ADDENDUM NO. 1
November 18, 2011

Project: **City Hall Public Restrooms**
 Sausalito, California
 Don Olsen Architects

From: Loren Umbertis
 Division Manager, Public Works
 Sausalito, CA 94965

ELECTRICAL LAYOUT
SCALE: 1/2" = 1'-0"

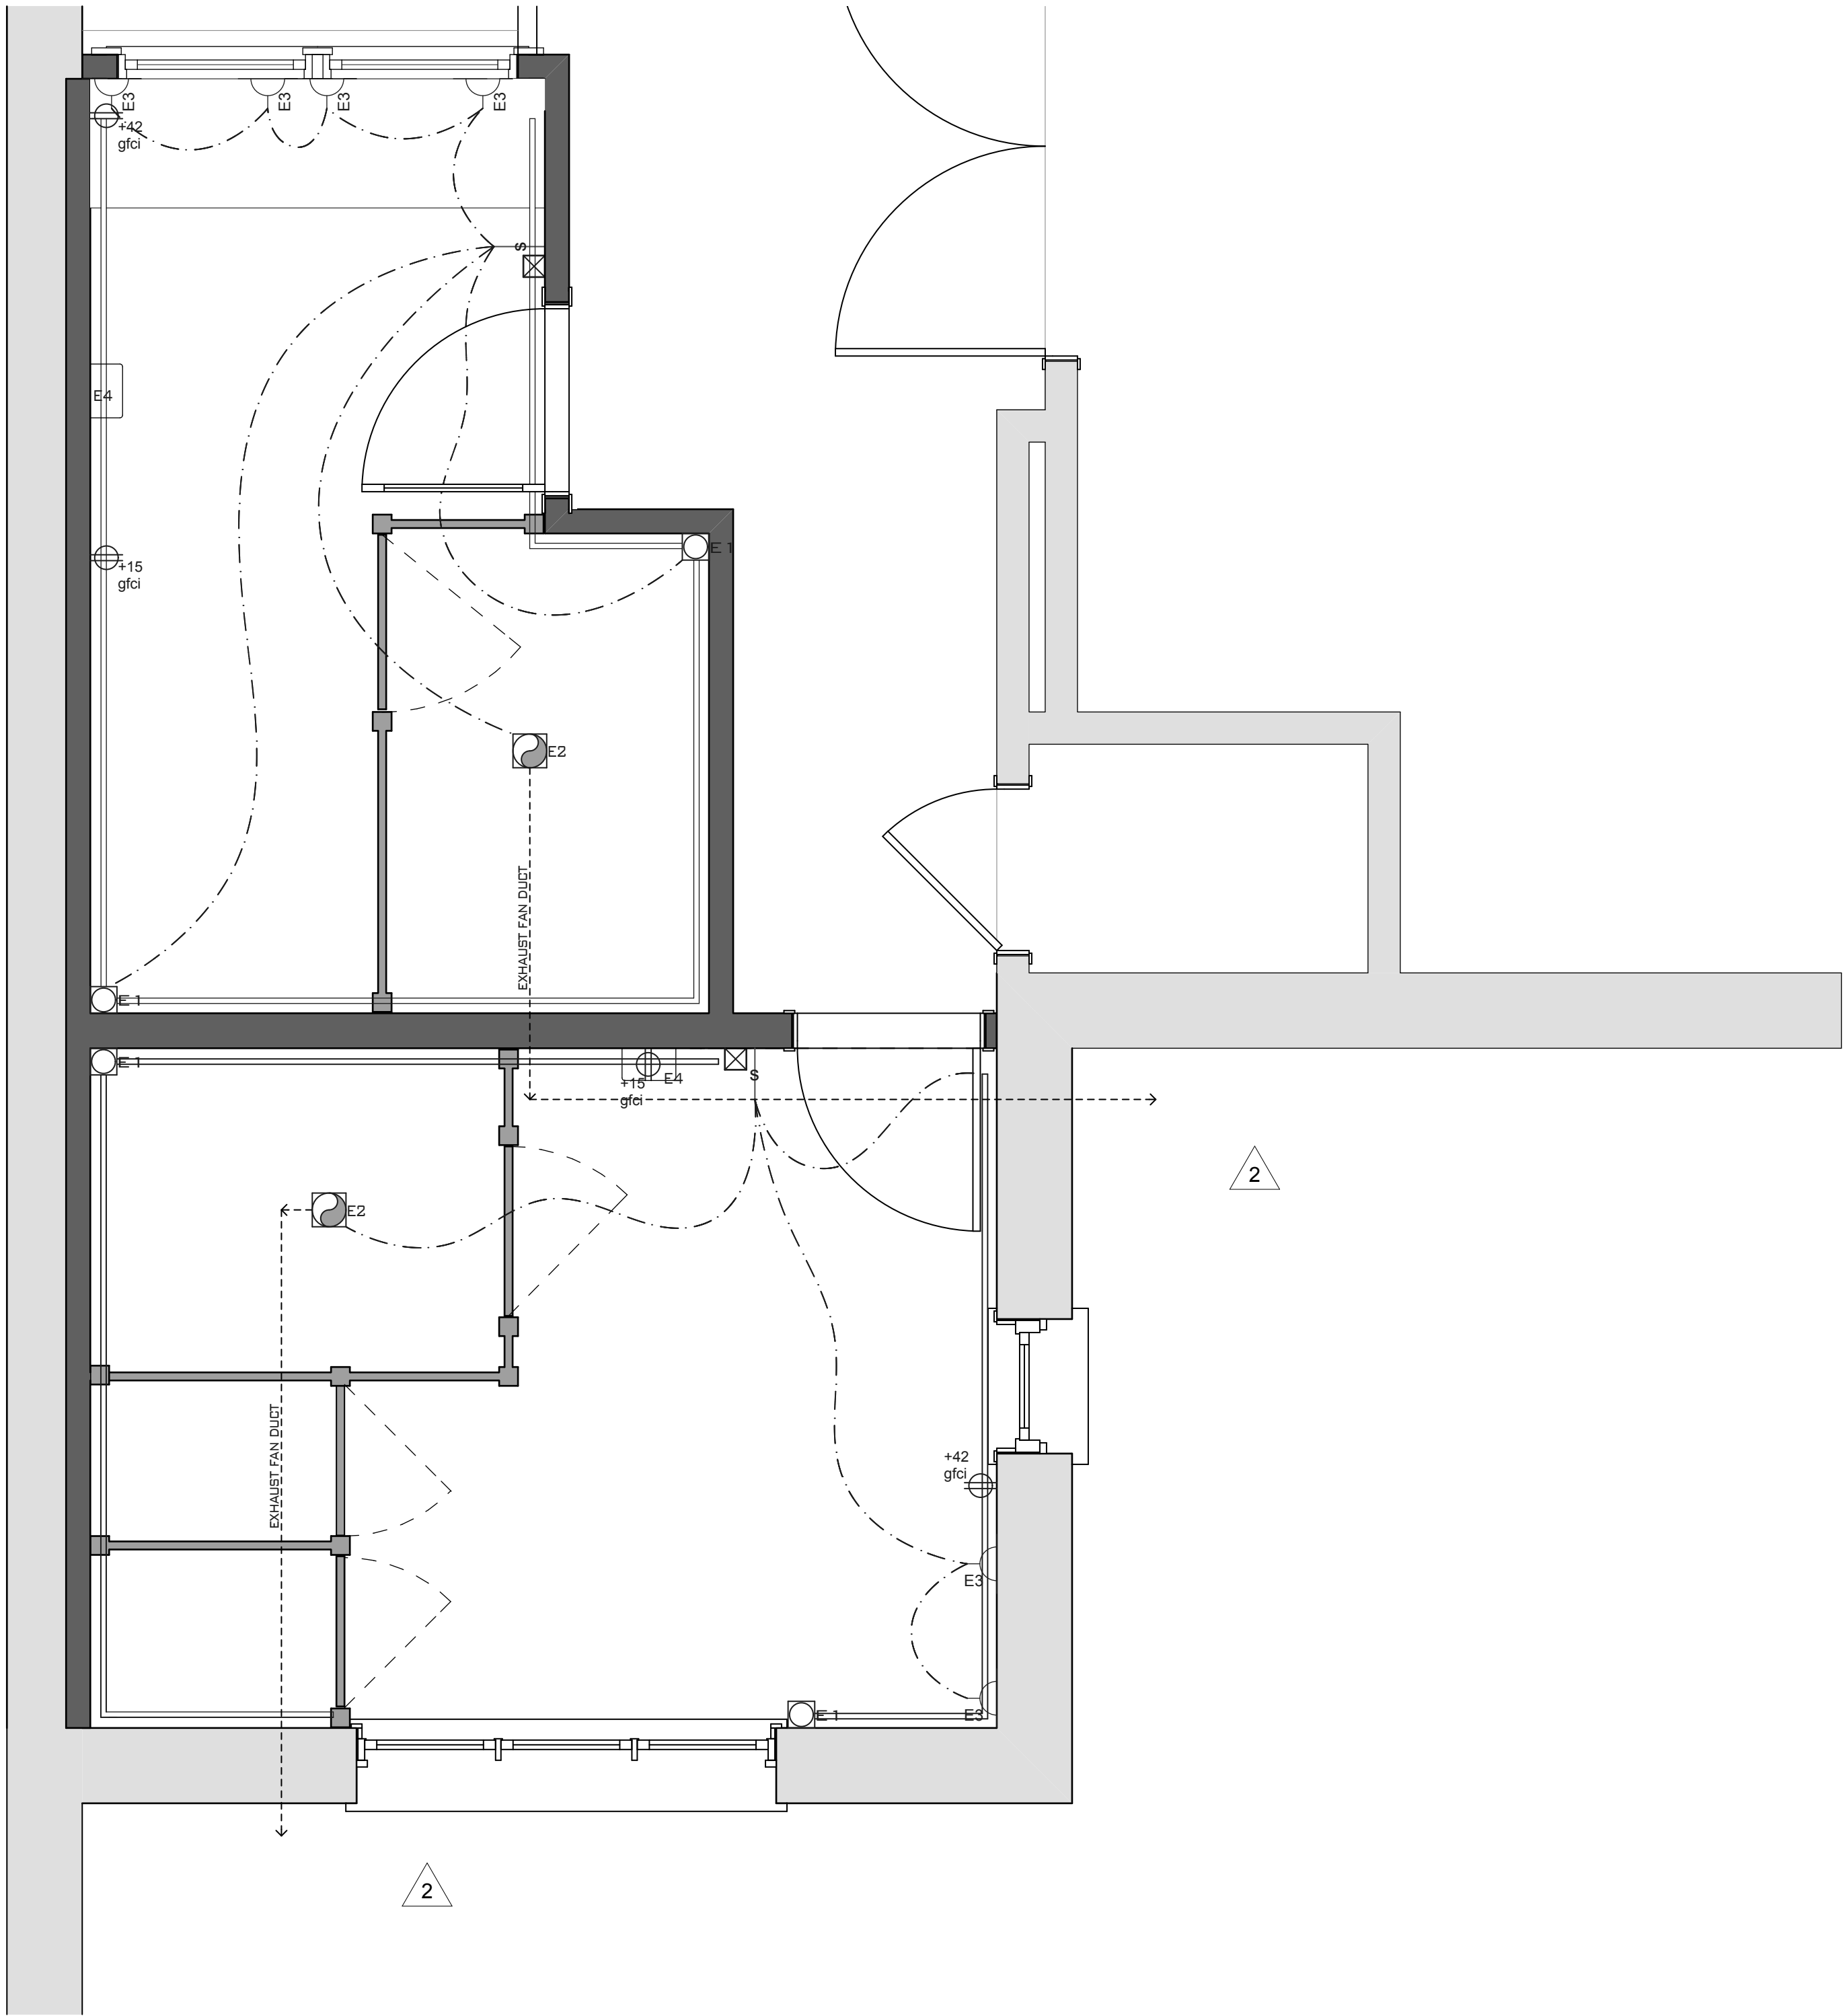
11. **Q: Handryers are noted on one page but not another, could architect please clarify?** A: Architect has included additional information regarding the Hand Dryers on the electrical plans.
